Date: October 18, 2007

To: T10 Committee (SCSI)

From: George Penokie (IBM)

Subject: SPC-4: UML model for CbCS

Figure 1 — CbCS overview class diagram

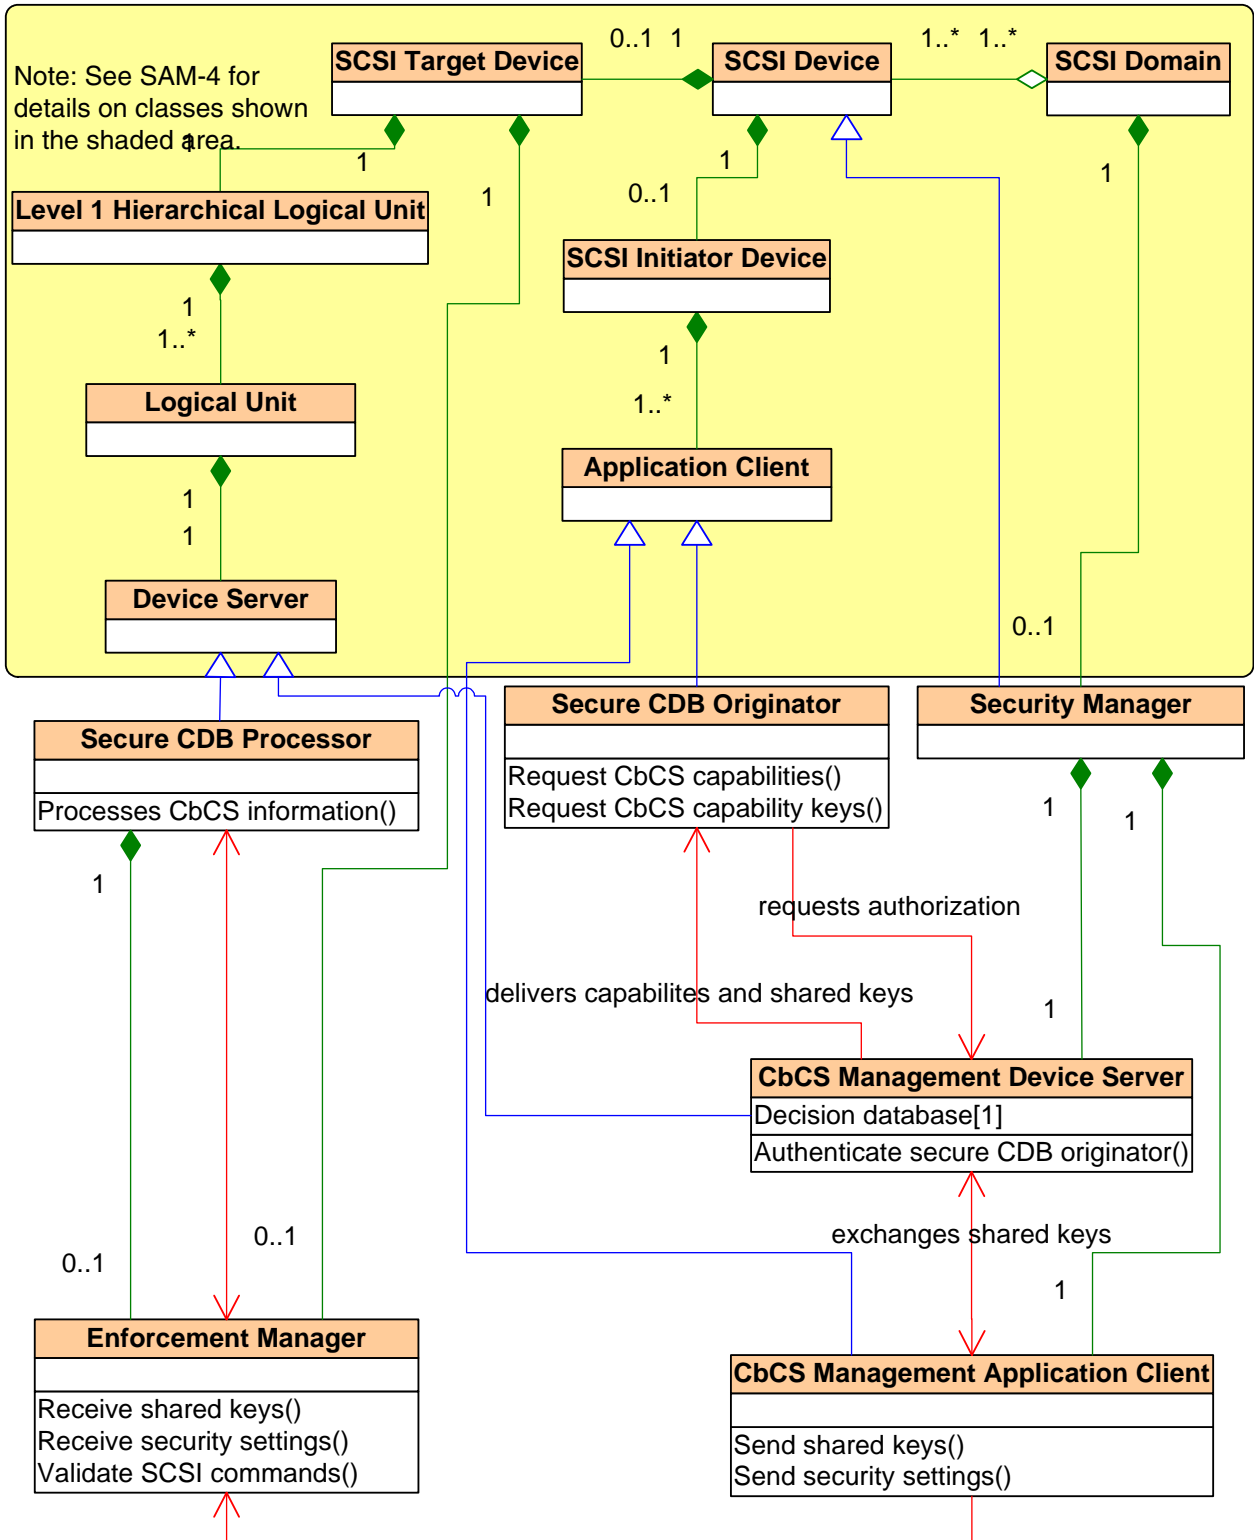
CbCS (see figure 1) is composed of a:

- a) Security Manager class (see 5.13.5.2) that contains:
 - A) A CbCS Management Device Server class (see 5.13.5.3); and
 - B) A CbCS Management Application Client class (see 5.13.5.4).
- b) SCSI Initiator Device class (see SAM-4) that contains:
 - A) A Secure CDB Originator class (see 5.13.5.5);
 and
- c) SCSI Target Device class (see SAM-4) that contains:
 - A) A Secure CDB Processor class (see 5.13.5.6);and
 - B) An Enforcement Manager class (see 5.13.5.7);

Figure 1 shows the flow of transactions between the components of a CbCS capable SCSI domain.

Each instance of CbCS shall contain:

- a) one security manager that shall contain:
 - A) one CbCS management device server; and

- B) one CbCS management application.
- b) one or more SCSI initiator devices that shall contain:
 - A) one or more secure CDB originators;
 and
- c) one or more SCSI target devices that shall contain:
 - A) one secure CDB processor per logical unit; and
 - a) one enforcement manager per secure CDB processor;
 - b) one enforcement manager per SCSI target device; or
 - c) both.
